**Subject:** Nuclear Industry Comments on the Technical Basis for New Performance-Based  
Emergency Core Cooling System Requirements

**Project Number: 689**

**Comments on the Adequacy of Technical Information in  
RIL-0801 and NUREG/CR-6967 Requested in Federal Register Notice**

**Figure 1. Comparison of ANL & CEA Post-Oxidation Ductility Offset Strain vs. CP-ECR. Samples were oxidized at 1200°C and have a hydrogen content of approximately 600 wppm.**

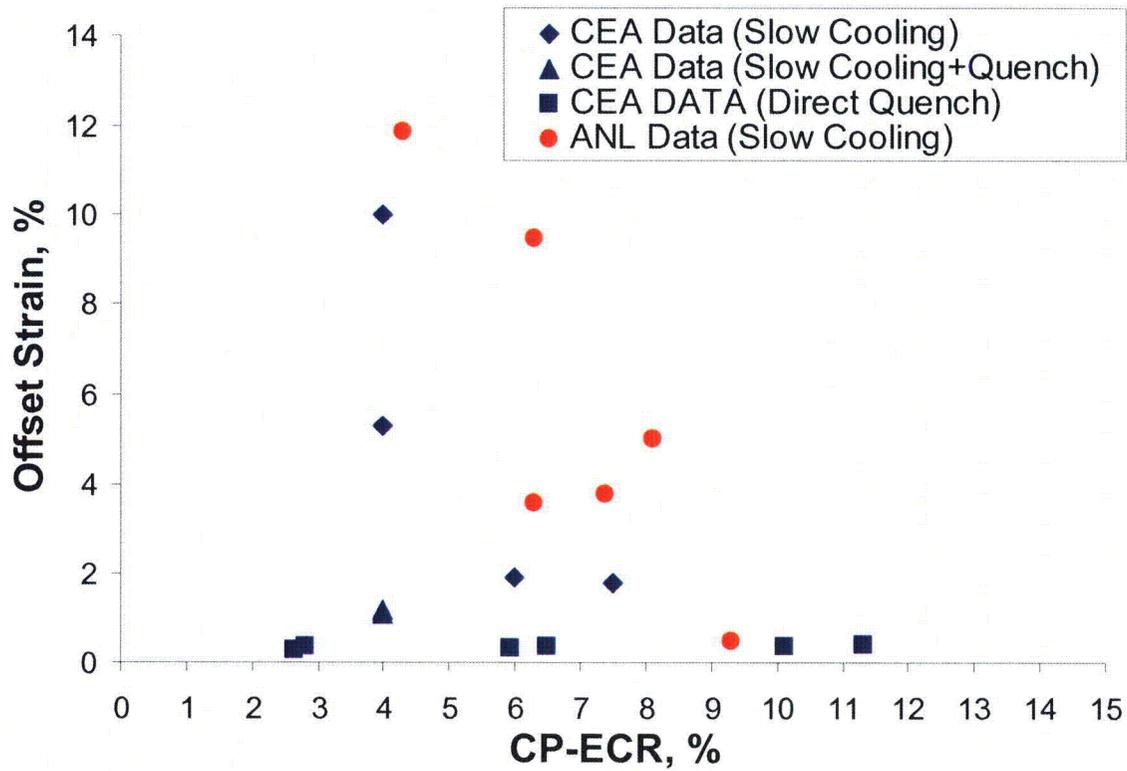
The ANL program combines separate effects tests and integral tests to evaluate the impact of burnup on fuel rod behavior during a LOCA. However, many of the ANL observations on prehydrided and irradiated samples are not consistent with results obtained at overseas facilities such as CEA/EDF/Framatome (France). Figure 1 highlights some of the differences in the ductility data for samples with a hydrogen content of approximately 600 wppm that have been oxidized at 1200°C.

Figure 2. Thermal benchmark results from two tests, each with two thermocouples welded onto as-fabricated, HBR-type 15×15 Zry-4 cladding.

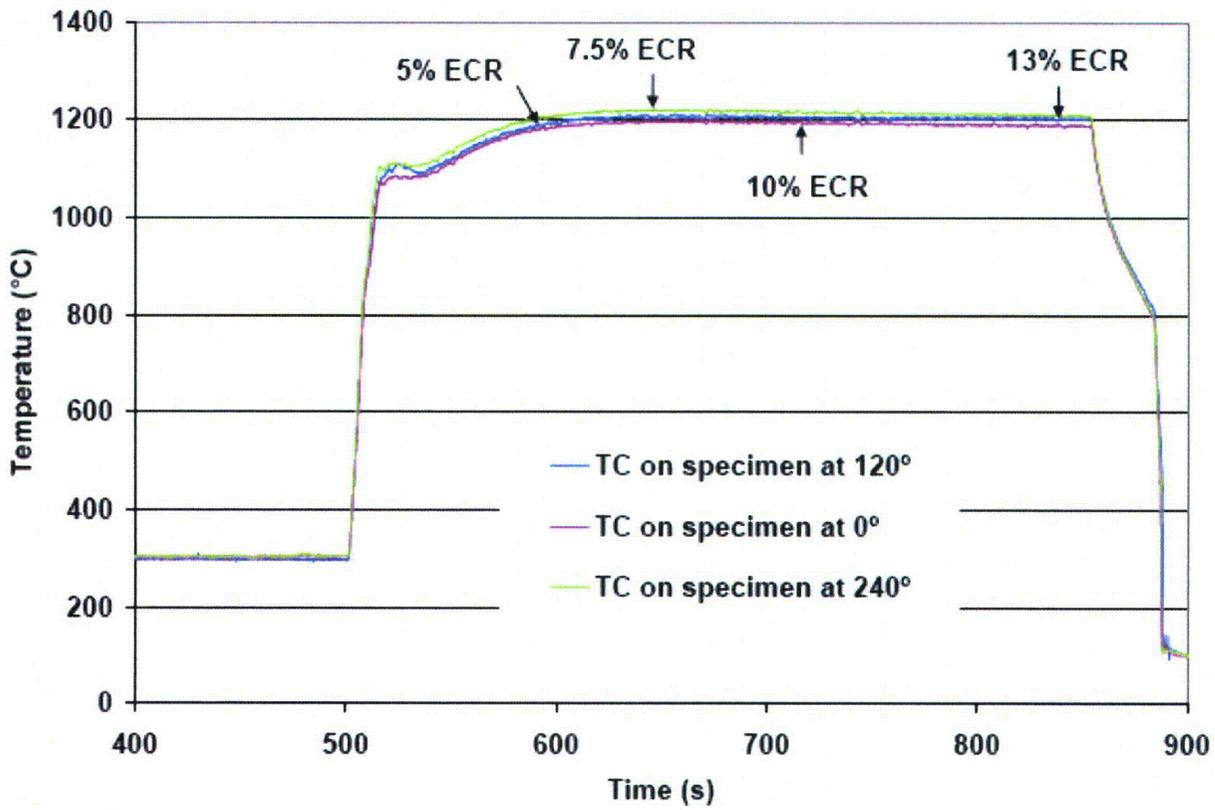
There are lab-to-lab differences in the sample preparation that can contribute to differences in ductility measurements. First, there is no "typical" LOCA temperature history applied by all experimentalists during the sample oxidation process. The temperature history used to oxidize and cool the samples plays a key role in the eventual sample ductility. ANL has a fast initial ramp followed by a slow approach to the final oxidation temperature to avoid a temperature overshoot. CEA has a direct ramp to temperature without overshoot. The ANL heating method is presented in Figure 2 and results in less total oxidation at target temperature (i.e. 1204°C). The CP-predicted ECR values have been placed on Figure 2 temperature history in order to demonstrate the effect on ECR accumulation associated with the non-isothermal oxidation process used by ANL. (The ANL samples accumulate ~5% ECR before even reaching the target limiting temperature. Actual LOCA scenarios would accumulate even more ECR before approaching the temperature acceptance criterion.)

**Figure 3. Comparison of ANL data (irradiated and pre-hydrated)**

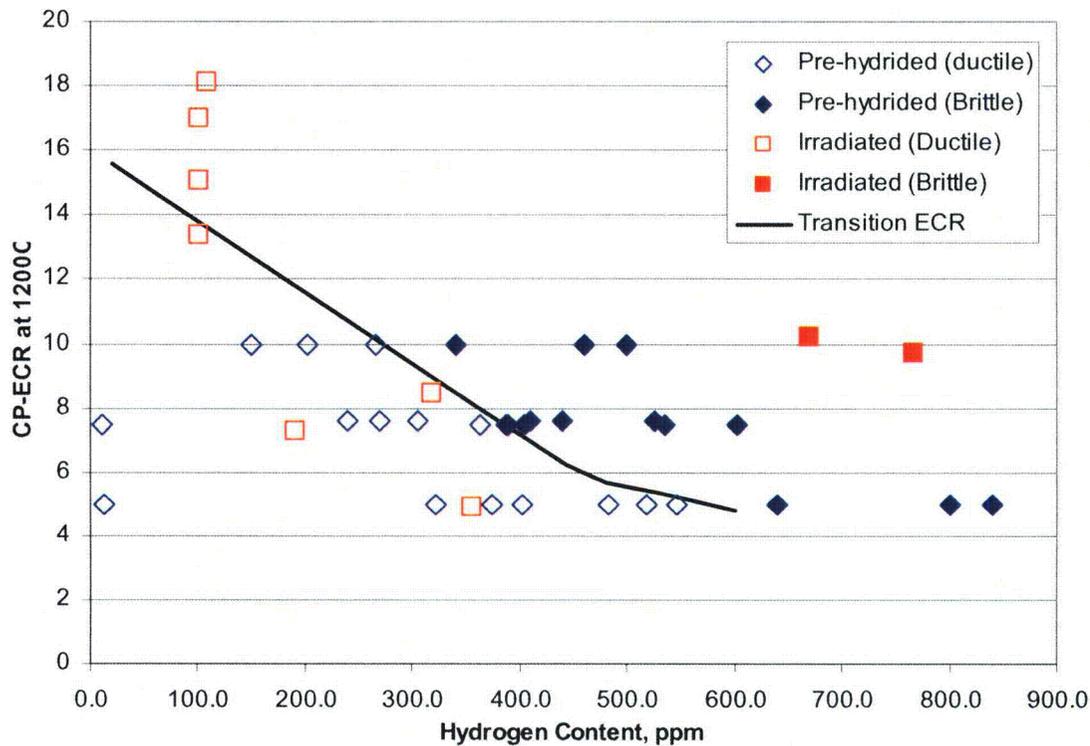
A review of ANL data that was oxidized at 1200°C and slow cooled to room temperature is presented in Figure 3 and shows that the behavior of irradiated cladding and pre-hydrated cladding is similar. Thus we can conclude that there is sufficient technical basis to justify testing on unirradiated, hydrogen charged surrogate specimens.

**Figure 4. GE-14 Fuel Design Calculated PCT Response to a typical LOCA Event with and without Crud**

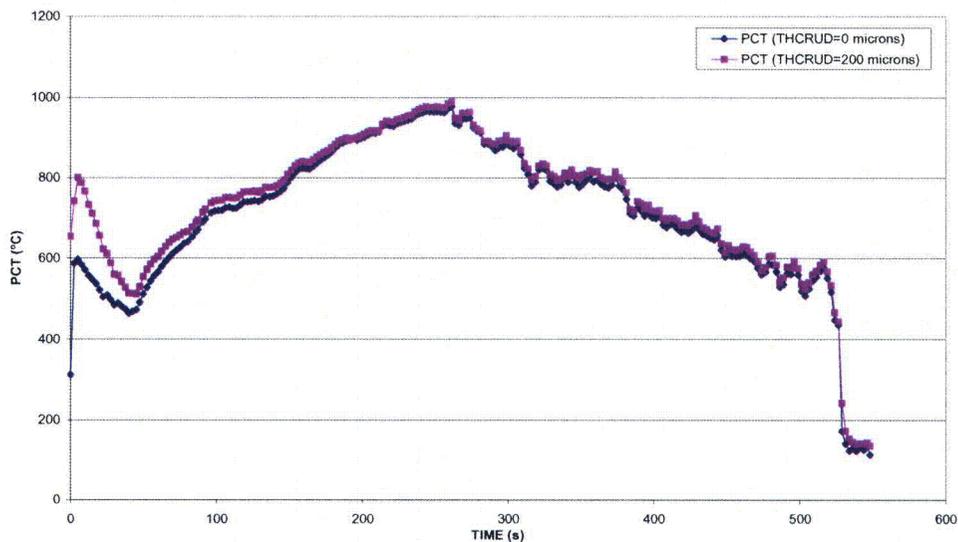
An example of a BWR analysis that demonstrates the potential effect of crud is presented in Figure 4. This analysis compares the PCT response of a typical fuel rod during a normal LOCA transient to the same fuel rod with the addition of crud. A conservative value for the thermal conductivity of the crud is assumed in the analysis. The analysis demonstrates that the principal result of the crud addition is to increase the initial calculated PCT and early peak temperature. Once the initial stored energy is mitigated, crud no longer has a great effect on PCT. This behavior is also typical of PWR fuel rod response.
